**ALERT SERVICE BULLETIN**

**214-18-77**

**MODEL AFFECTED:** 214B/B-1

**SUBJECT:** MAIN DRIVESHAFT OUTER COUPLING 214-040-659-005, INSPECTION OF.

Figure 1. Crack Indications

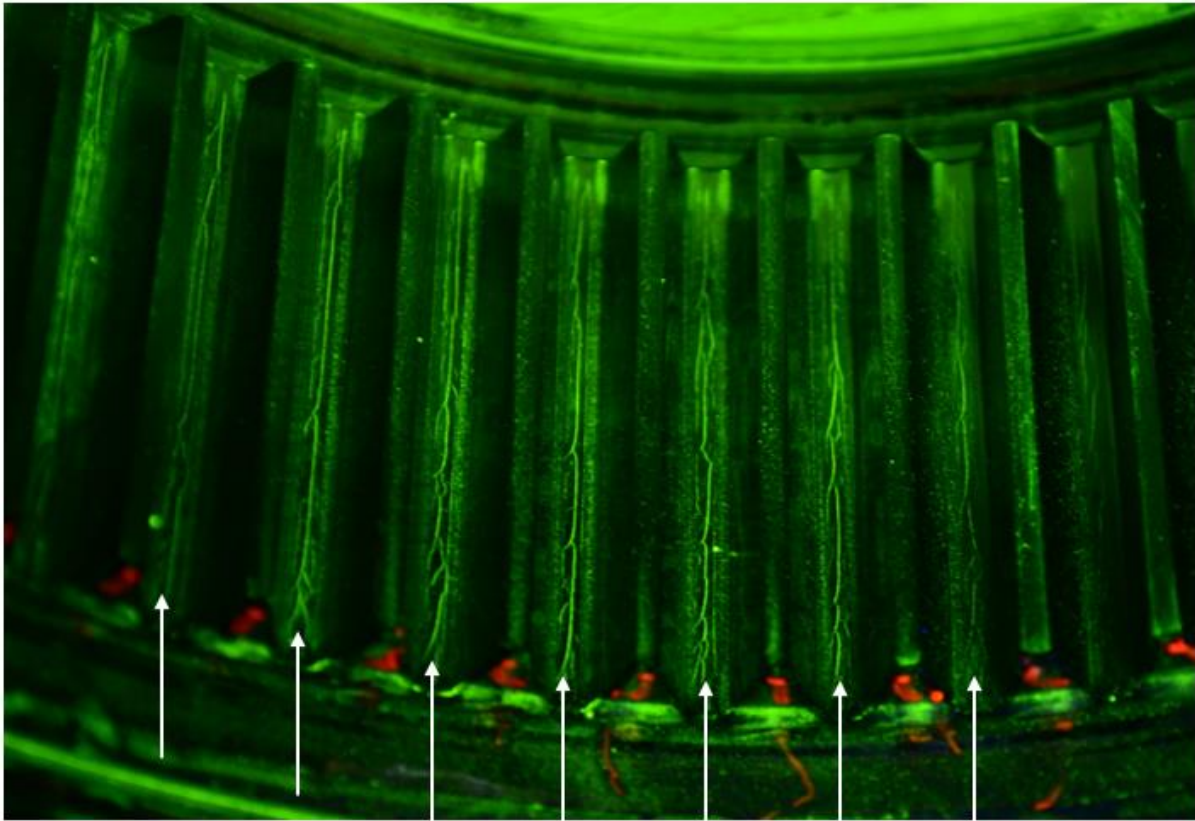
Bell Helicopter has found that some main driveshaft outer couplings 214-040-659-005 may have a manufacturing defect. The defect, which was found to be cracks induced during manufacturing of a particular lot of parts, is in the root of the splines and can be detected by magnetic particle inspection (MPI) as shown in Figure 1. Six outer couplings are in the affected manufacturing lot, see Table 1 in the Accomplishment Instructions section for the list of serial numbers.

1. Prepare the helicopter for maintenance.
2. Remove the main driveshaft. (BHT-214-MM)
3. Disassemble the driveshaft to the extent necessary to remove the affected outer couplings 214-040-659-005. (BHT-214-CR&O)
4. Inspect the coupling for cracks by MPI, no cracks are acceptable. Pay particular attention to the coupling spline root area. (BHT-214-CR&O and BHT-ALL-SPM)
  - a. If cracks are found replace the affected 214-040-659-005 outer coupling. If no cracks are found, return the part to service.
5. Re-assemble and install the main driveshaft. (BHT-214-CR&O and BHT-214-MM)
6. Make an entry in the helicopter logbook and historical service records indicating compliance with Part II of this Alert Service Bulletin.

Crack indications in root of splines

Figure 2.  
Serial Number marking location

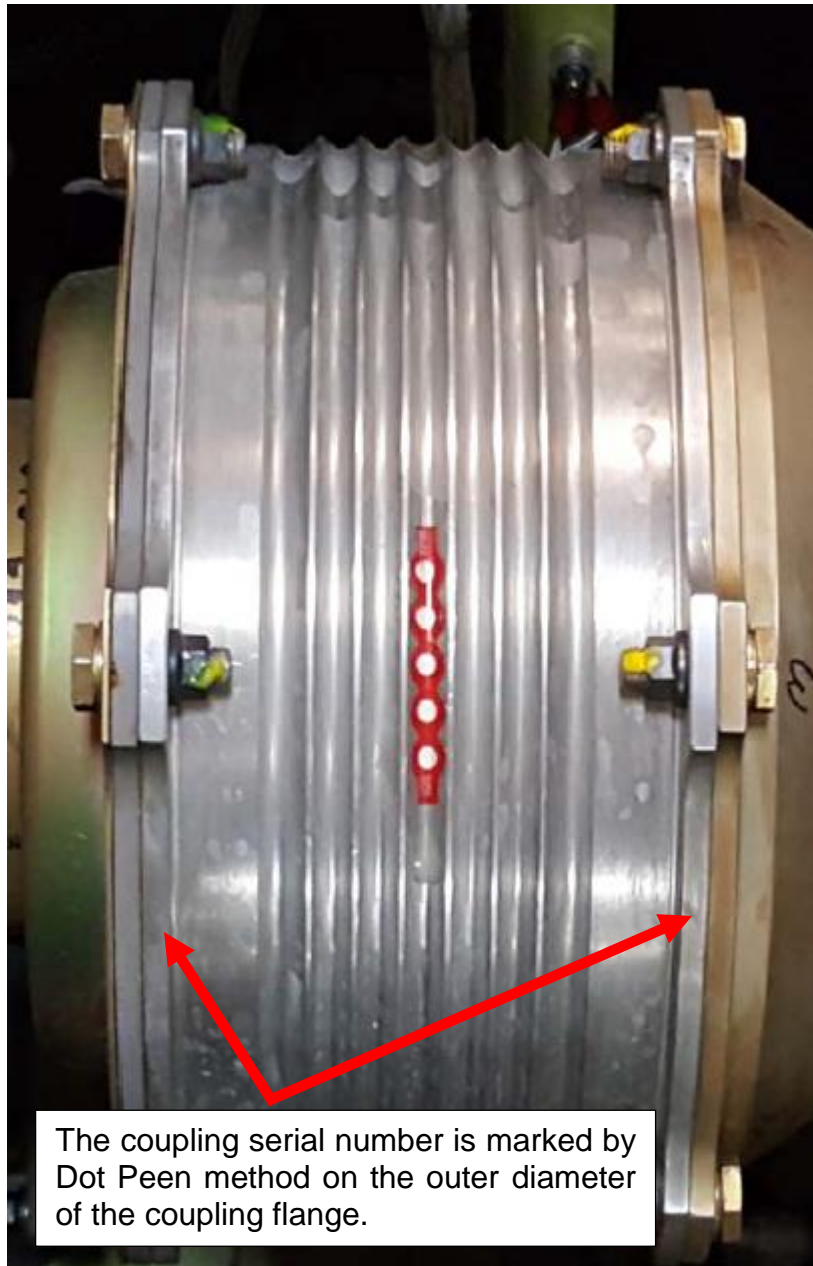
The serial number is marked by Dot Peen method on the outer diameter of the coupling flange. (Figure 2)

2. Visually confirm the forward and aft 214-040-659-005 outer couplings' serial number.
  - a. If the coupling serial number is not listed in Table 1 or there are records showing that a MPI has previously been carried out with no crack indications, then no further action is required. Accomplish step 3.
  - b. If the coupling is affected and there are no records showing that a MPI has previously been carried out, then accomplish Part II within the specified compliance time.
